Explanation of Significant Differences
for the
Upper and Lower Harbor Operable Unit
New Bedford Harbor Superfund Site
New Bedford, Massachusetts

August 2002

U.S. Environmental Protection Agency
Region I - New England
Boston, MA

Figure 2
 Shoreline Facilities for Offsite Disposal
 February 2002 ESD

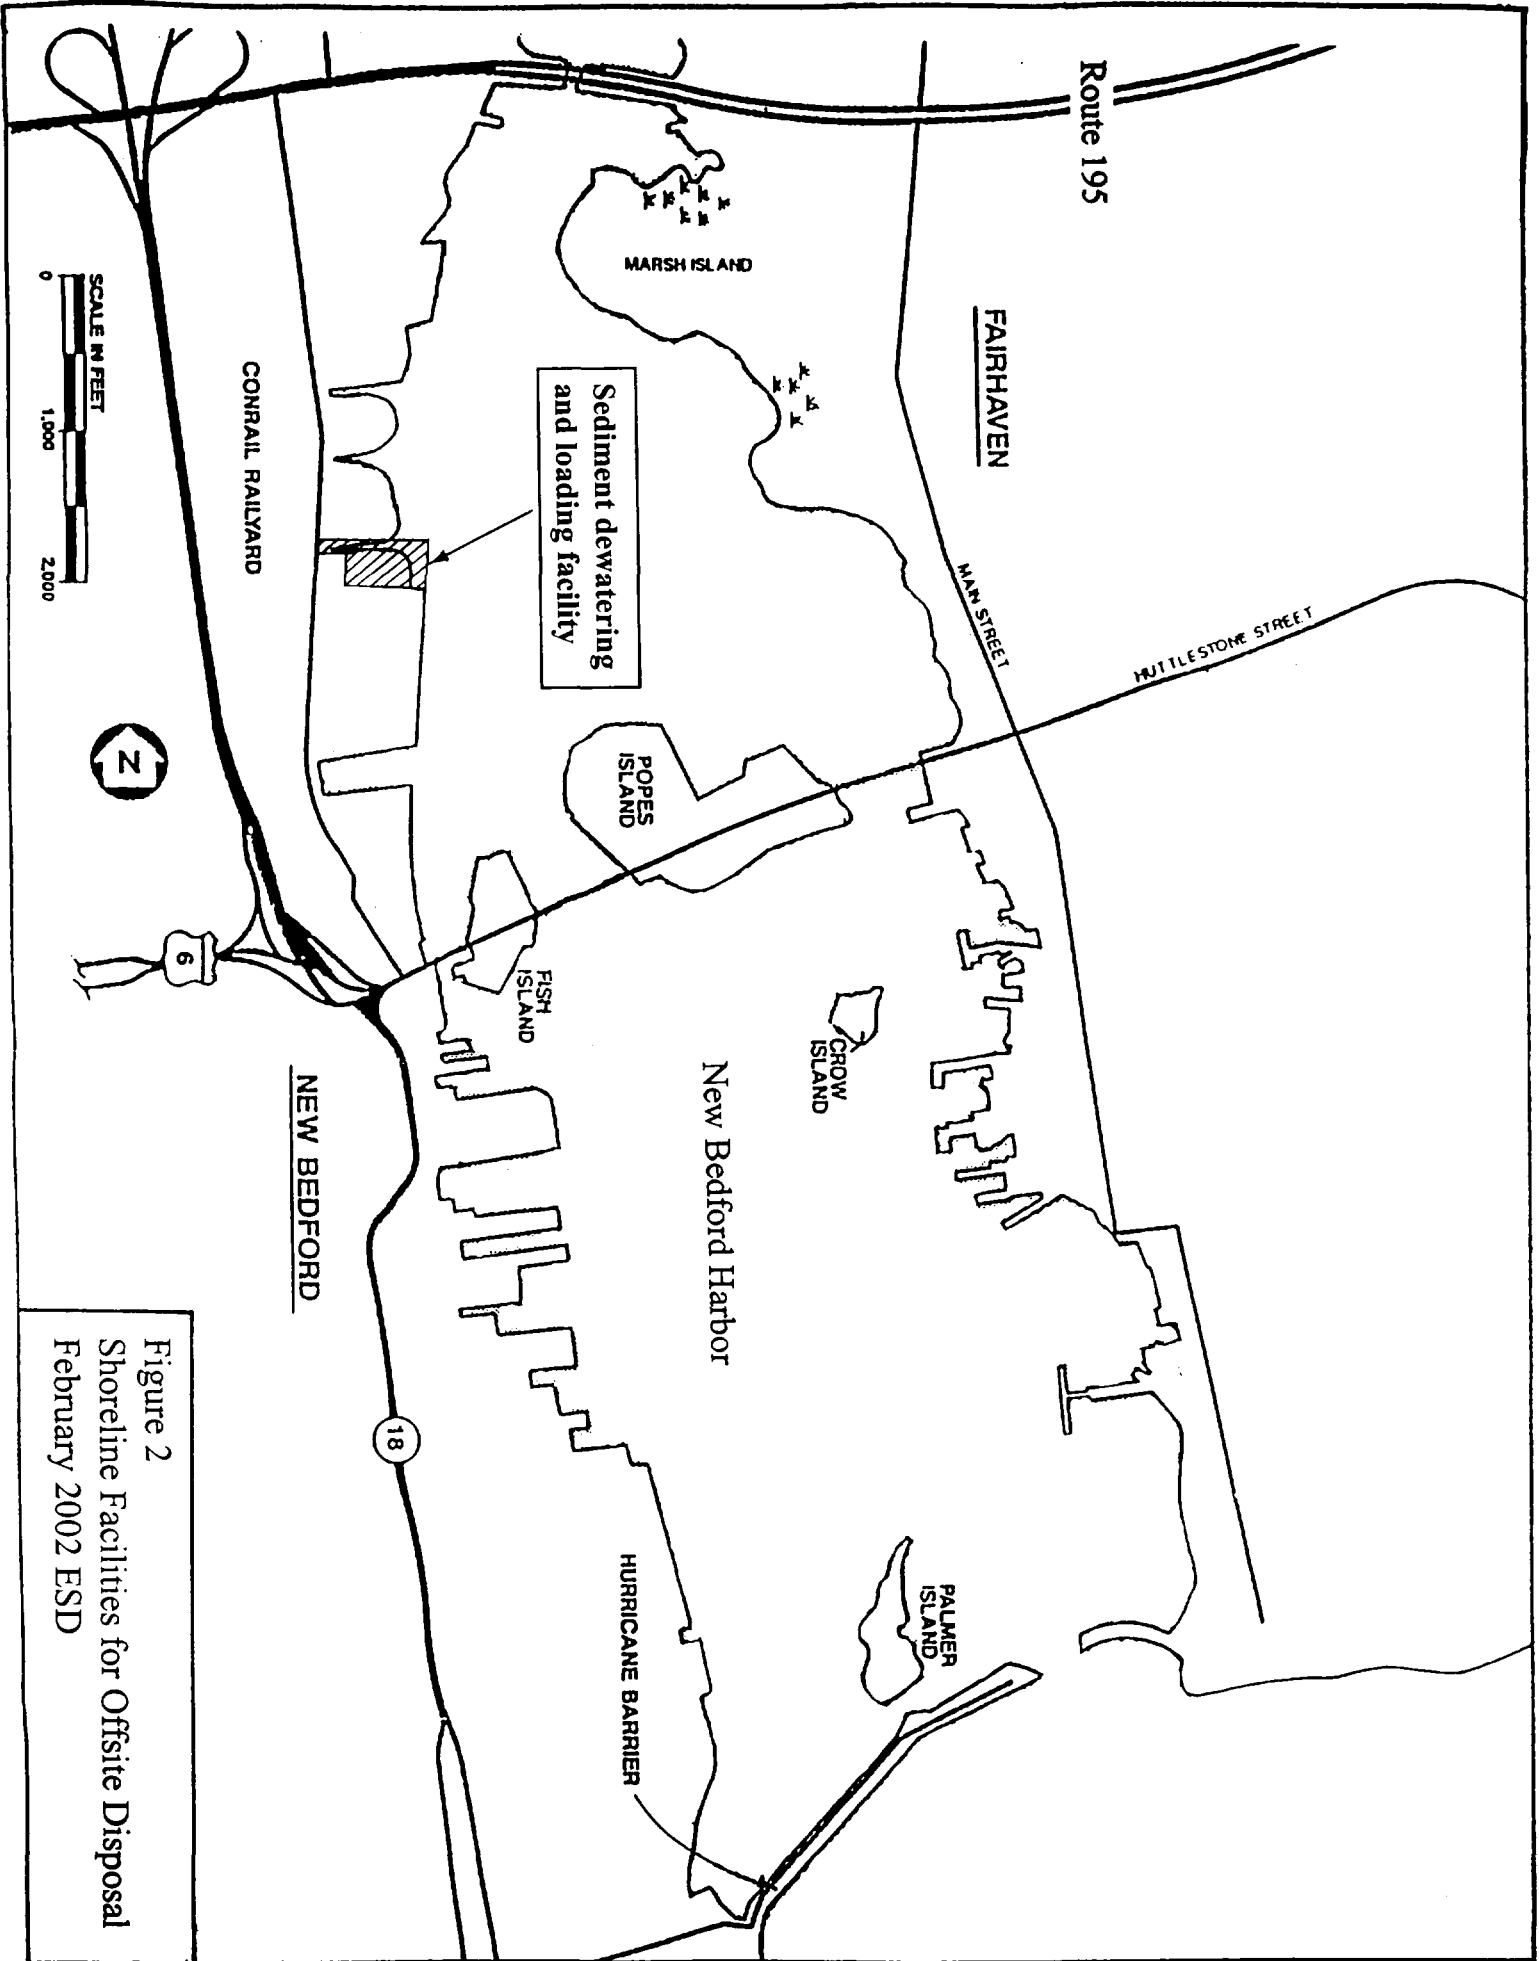
While this ESD eliminates the 17 acre CDF D, it does not eliminate extension of the rail spur into this area discussed in the September 2001 ESD. Instead of CDF D, a smaller shoreline facility will now be constructed in the same area to support both the sediment dewatering building and the rail car (or truck or barge) loading area required for offsite disposal of the dredged sediments. See Figure 2 for the location of this smaller dewatering and transfer facility. Figure 3 illustrates the larger area of fill that would be required for CDF D, based on the original conceptual design. Figure 4 provides a closer overhead view of the smaller dewatering and loading facility, as currently designed.

AREA D DEWATERING/
MATERIAL TRANSFER FACILITY

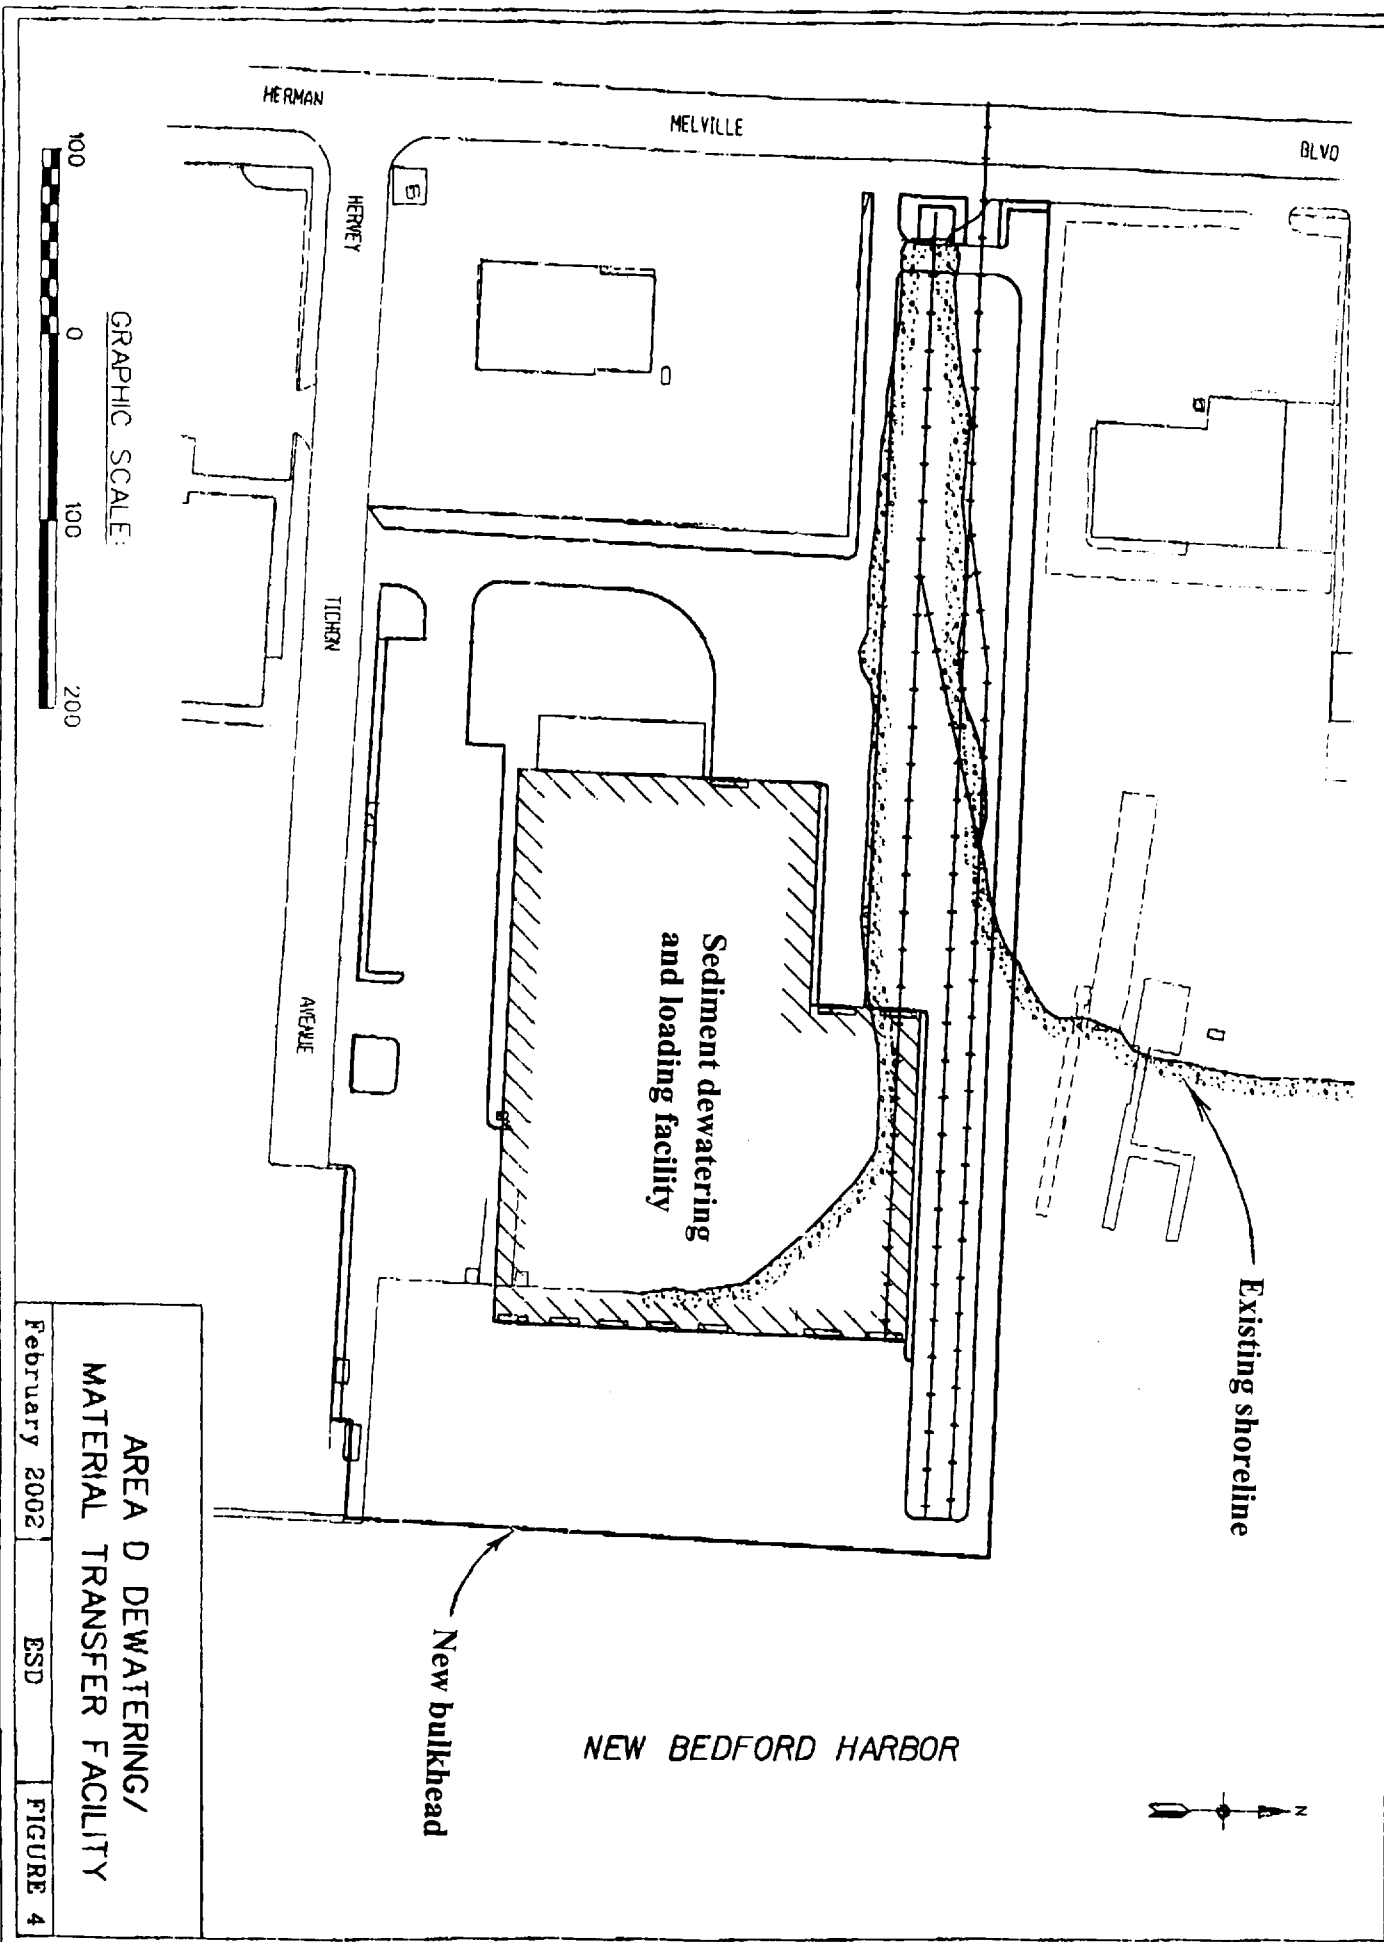
Under the offsite disposal option, the smaller scale shoreline facilities - the bulkhead, dewatering warehouse and rail spur - would be designed for future commercial marine reuse. Thus beneficial reuse of these facilities within the DPA once the cleanup is complete would be vastly streamlined and much less limited. Figure 4 shows a plan view of these features as currently designed.
